# UNITED STATES PATENT AND TRADEMARK OFFICE

APPLICATION NO.	FILING DATE	FIRST NAMED INVENTOR	ATTORNEY DOCKET NO.	CONFIRMATION NO.
10/635,047	08/05/2003	Nir Weiss	U014753-5	6959

**Office Action Summary**

## **DETAILED ACTION**

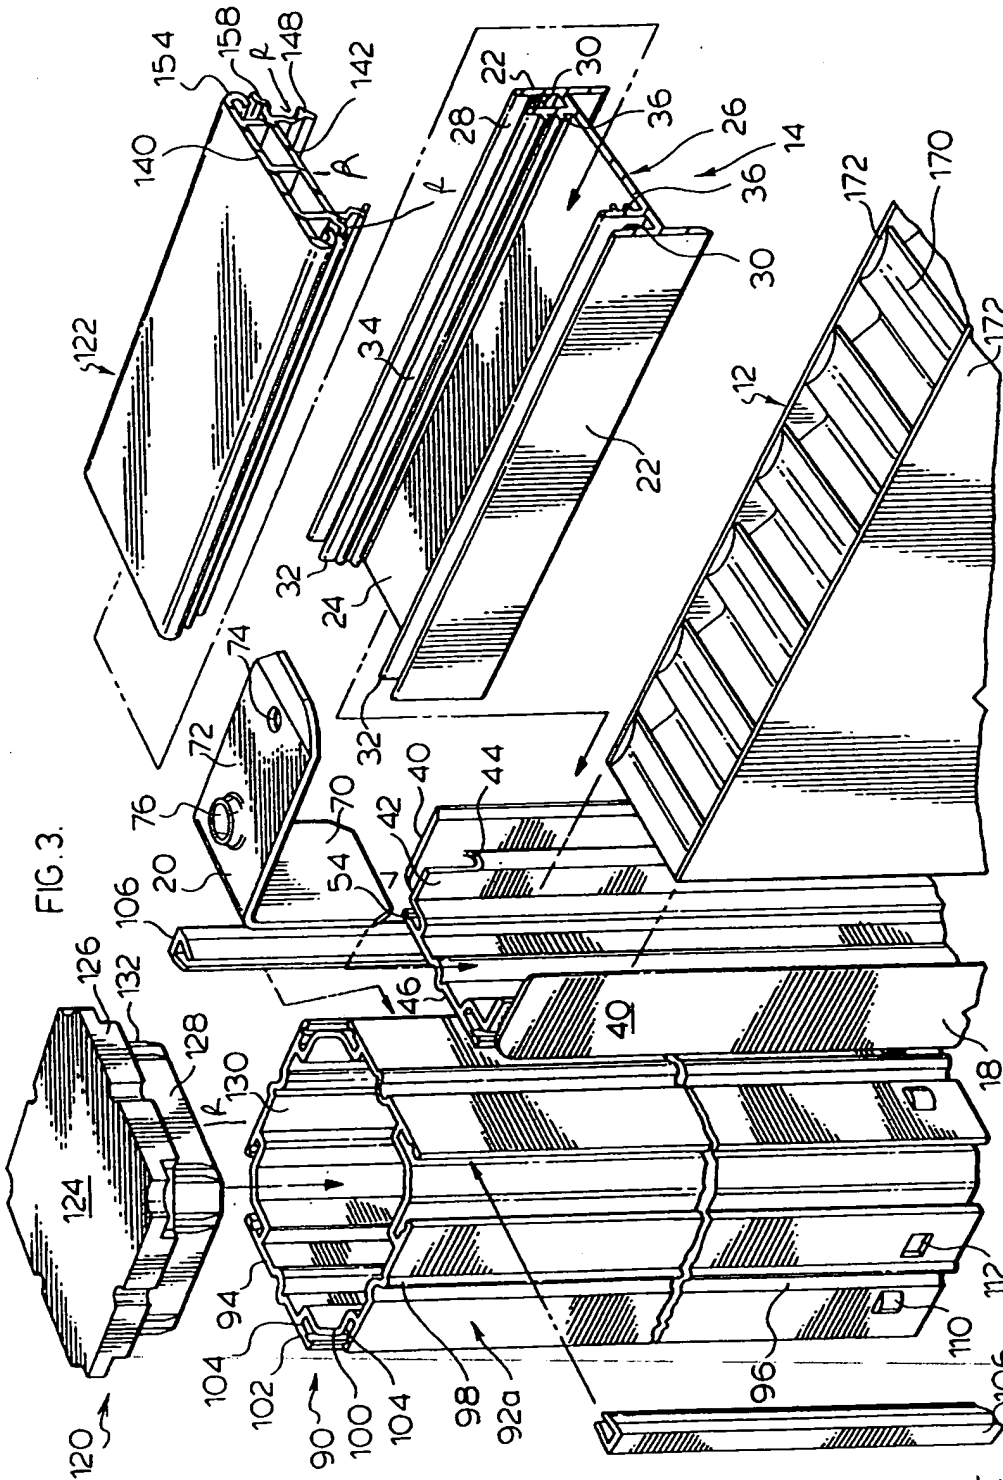
having a door panel 1 hingedly suspended between an upper U and lower L horizontal members (see attached fig. 1). At the time of the invention, it would have been obvious to a person of ordinary skill in the art to combine Muller with Schneider for a door hingedly suspended on the frame members. The motivation for doing so would have been to conveniently provide an entrance and an exit for the partition system.

FIG. 4.

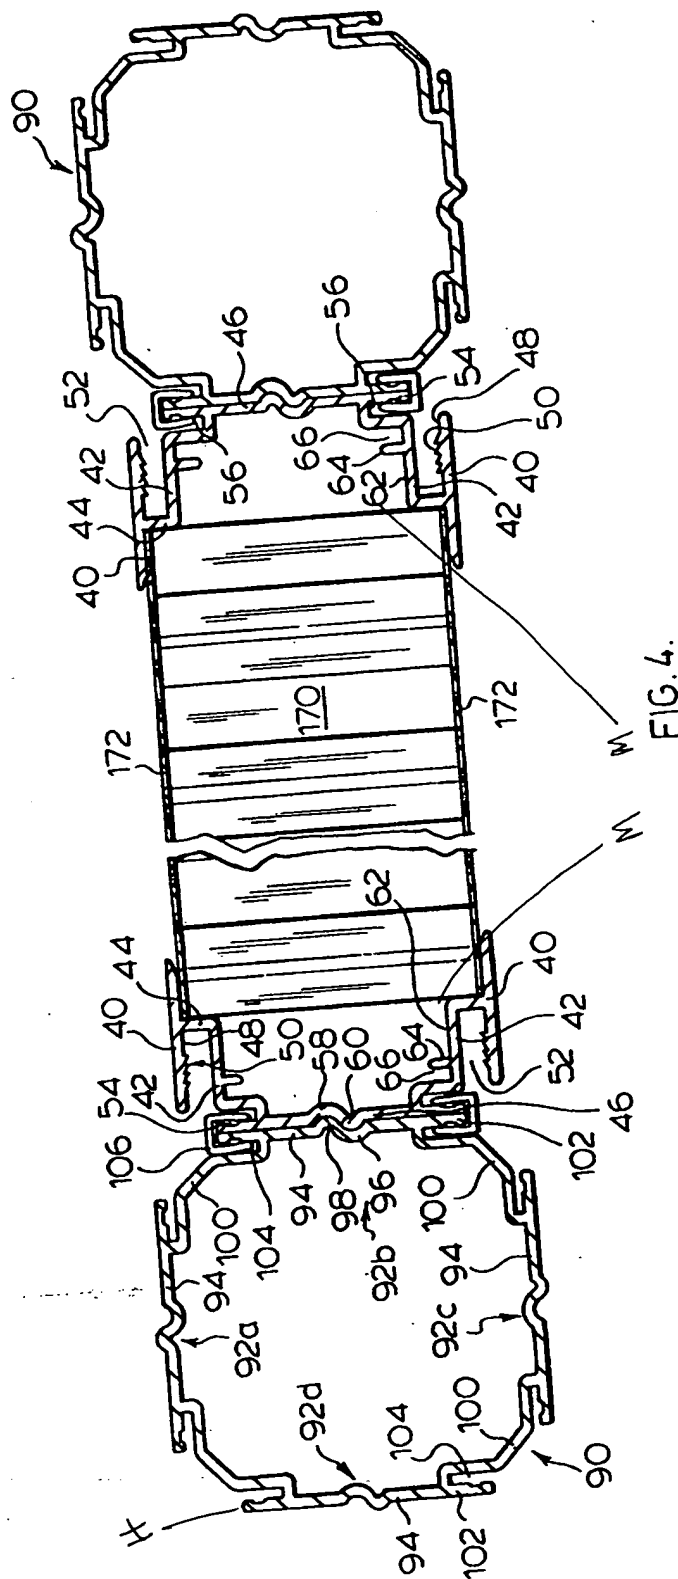
In regard claims 1-3, Muller shows in figures 3, 4 and 6, a panel member 12 having a top, a bottom, 170, two major surfaces 172 and two minor side surfaces M (see attached figure 4), a first of said minor surfaces being provided with a first profile 90 and a second of said minor side surfaces being provided with a second profile 90, wherein said first profile and said second profile are provided with mean 92a-92d for complementary engagement with a profile of an adjacently-positioned panel, and wherein each of said first profiles is provided with two inter-engagement mean arranged at angle of about 90-degrees to each other enabling the alternative inter-engagement of two adjacent panels with an angle of 180-degree therebetween, and at an angle of about 90-degree therebetween (see fig. 6), and the inter-engage means having a first curved recess 92d at the outer edge and a hook-like means H (see attached figure 4).
